**SOLICITATION ADDENDUM**

Issuing Agency:	Department of Transportation
Solicitation Number:	54-LC-12167363
Solicitation Description:	Mast Arm Poles
Solicitation Opening Date and Time:	March 3, 2025 at 2:00PM ET
Addendum Number:	1
Addendum Date:	February 27, 2025
Procurement Specialist:	Lyndsey K. Campbell

METAL POLE NO. 1

Design Loading for METAL POLE NO. 1, MAST ARM A

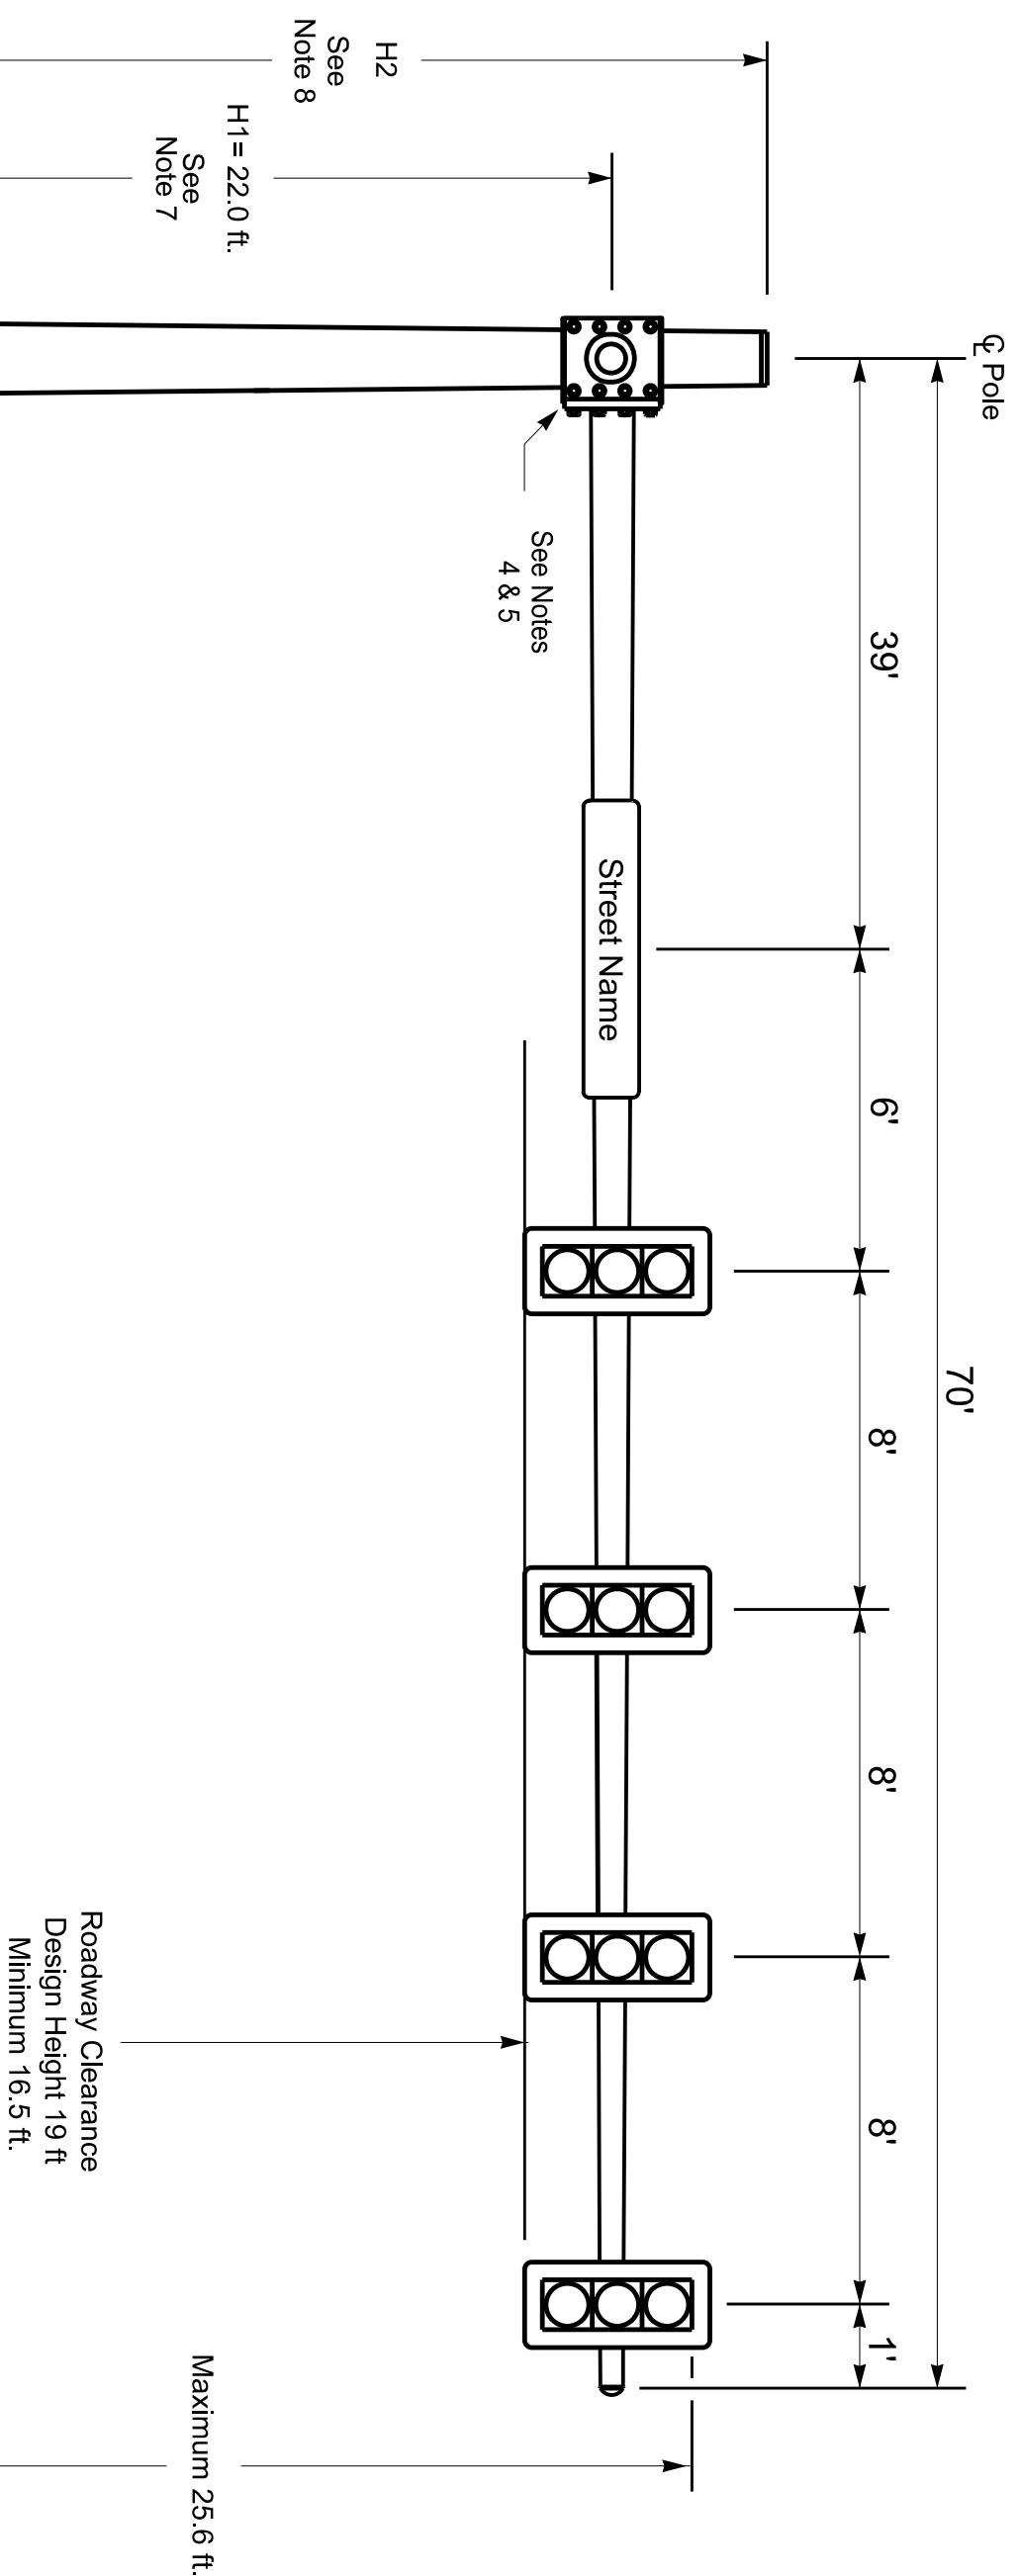
Question #	Solicitation Section	Vendor Question	State's Response
1	Exhibit A-C	Can you provide clearer drawings?	See Attached Pages
2			
3			
4			
5
